RE: Lycee Francais Renovation
1601 Leonidas Street
New Orleans, LA 70118
Proposal # 049-1

Proposal Request

PROJECT: *(name and address)*
LYCEE FRANCAIS DE LA
NOUVELLE-ORLEANS PRIESTLEY
RENOVATION
1601 LEONIDAS STREET, NEW
ORLEANS, LA 70115

Architect's Project Number: **15101**
Proposal Request Number: 04

01 SECOND FLOOR PLAN
1/8" = 1'-0"

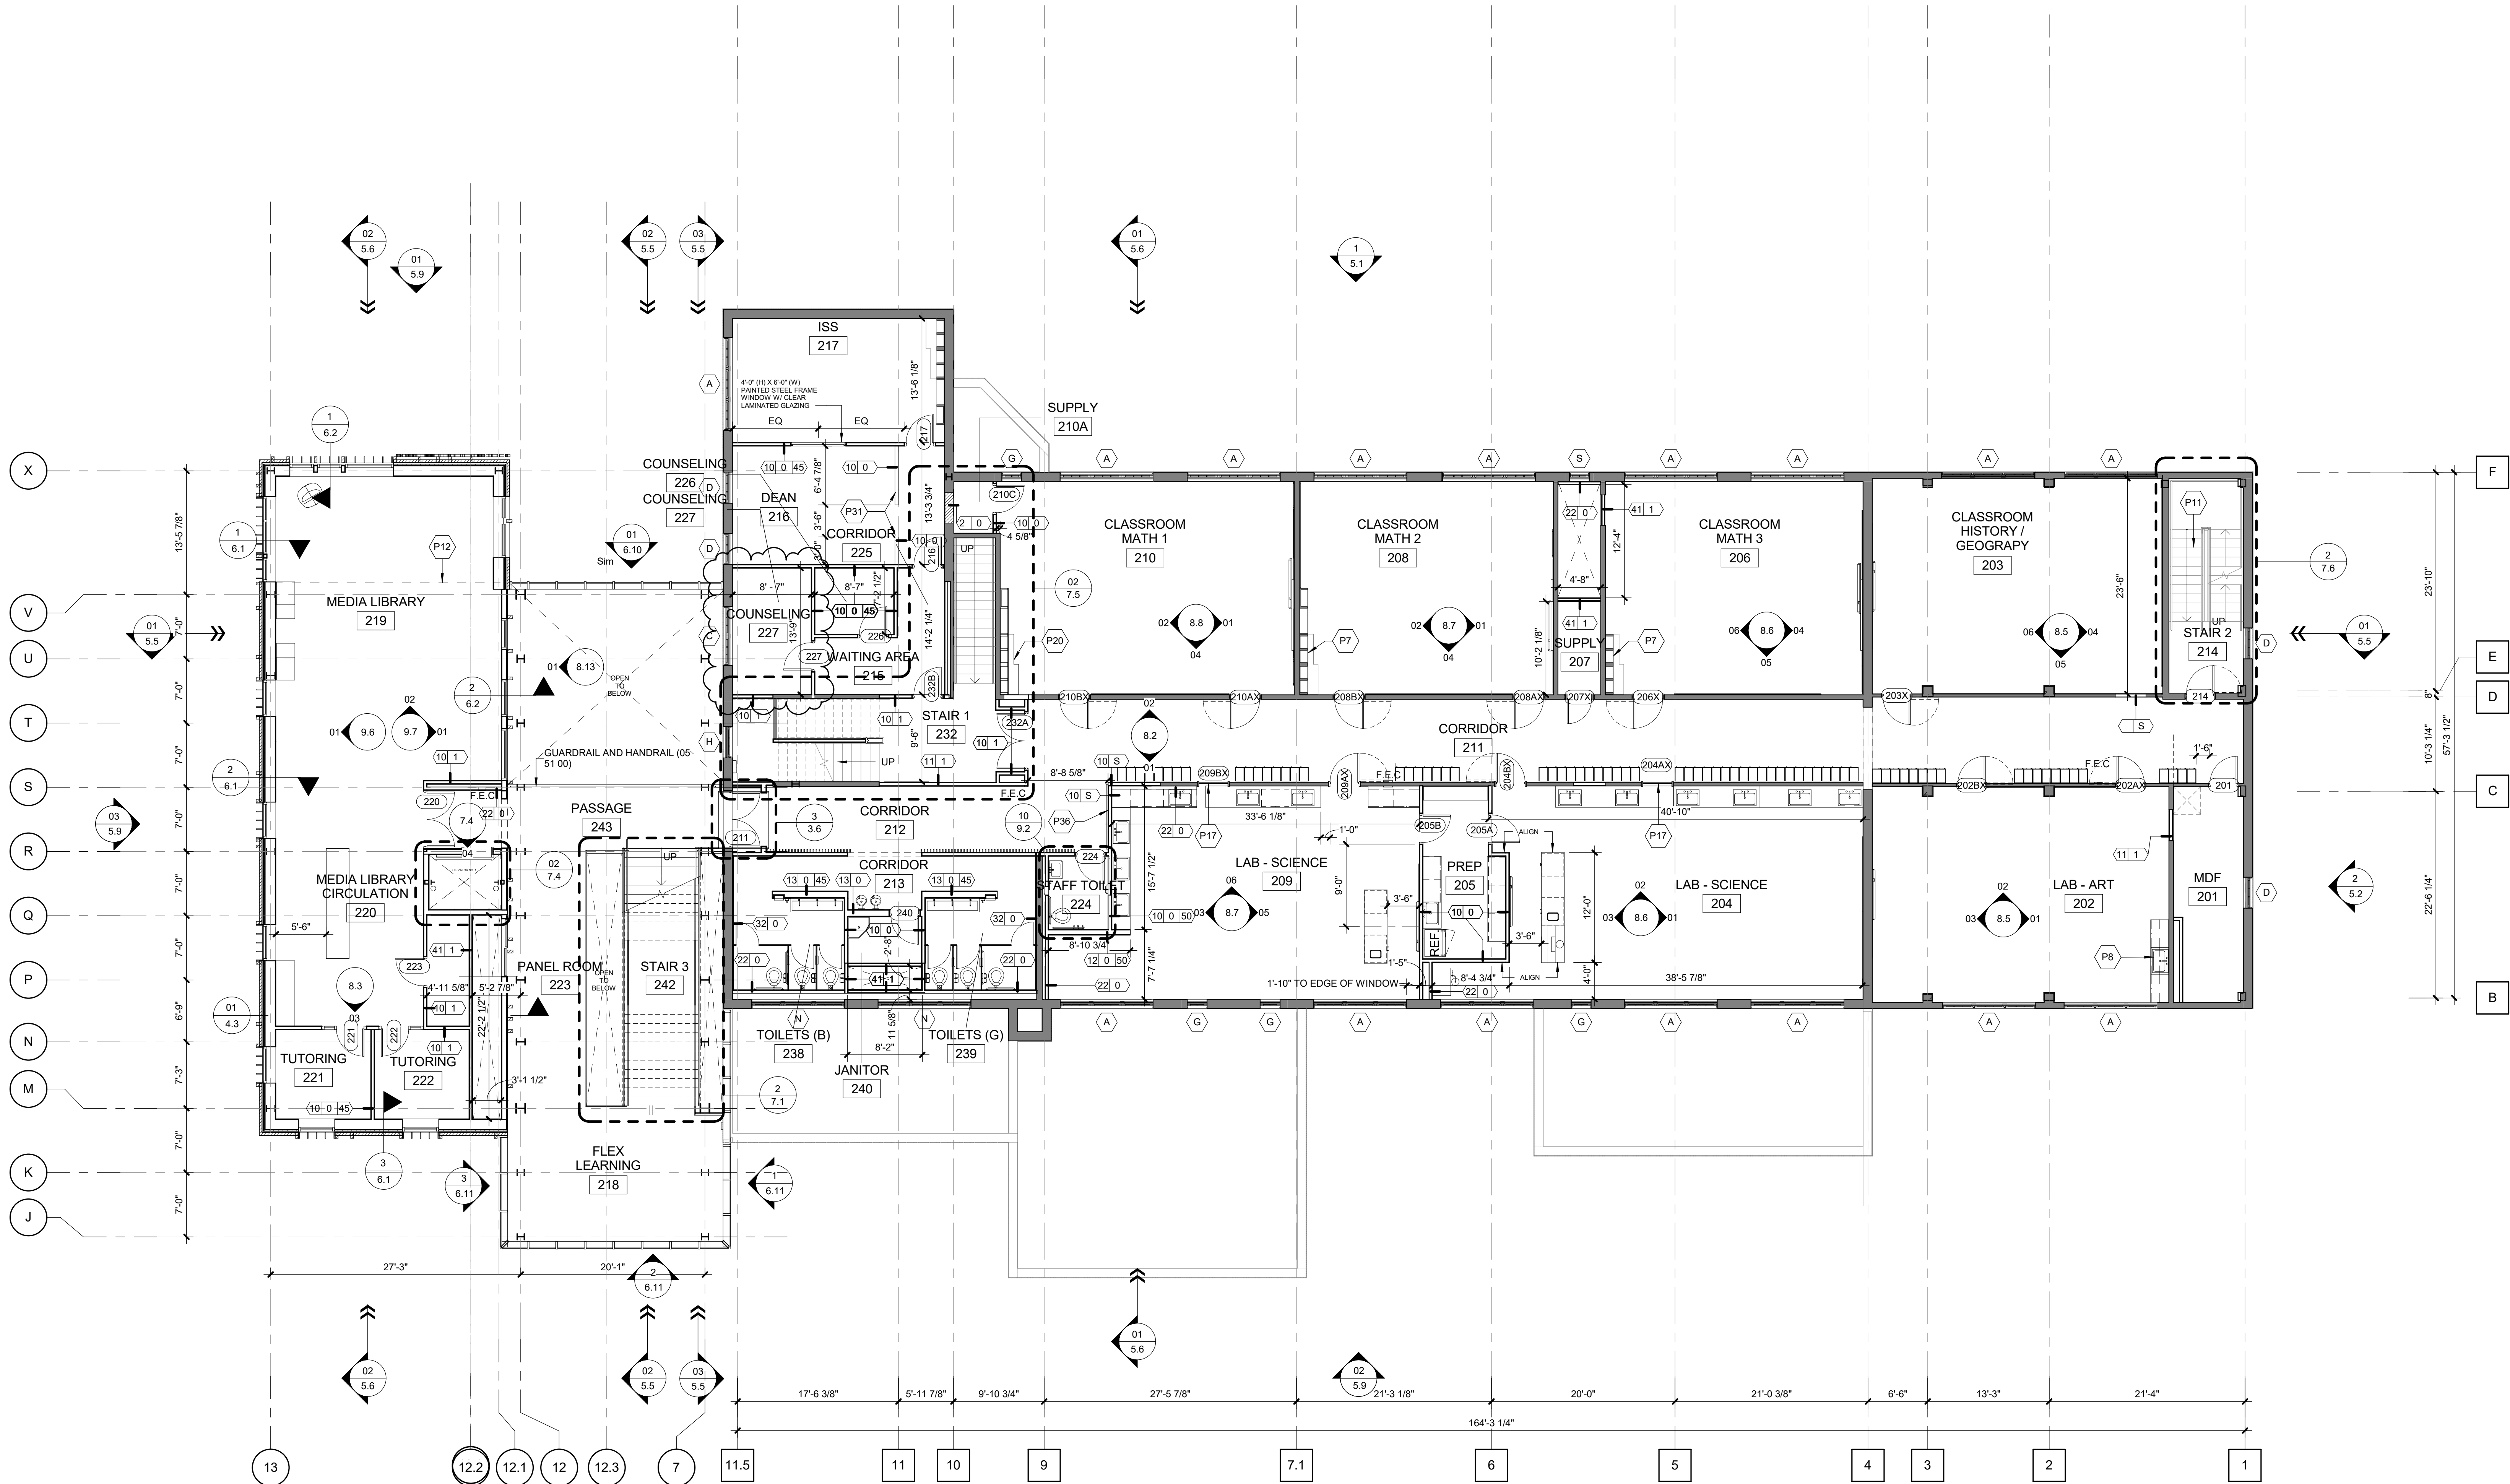
Acct/Finance 148: Changed dimension of the room and added a glass slider door (see cut sheet attached, door added to door schedule). Adjusted MEP accordingly. Provide price for changes to this room separately from the other work: \$ _____

Student Services 133 and Offices 134/135: Moved the two offices to the other end of the room. Adjusted ceiling plan and MEP accordingly. Provide price for changes to this area separately from the other work: \$ _____

Counseling 227: Adjusted layout of room. Adjusted ceiling plan and MEP accordingly. Provide price for changes to this room separately from the other work: \$ _____
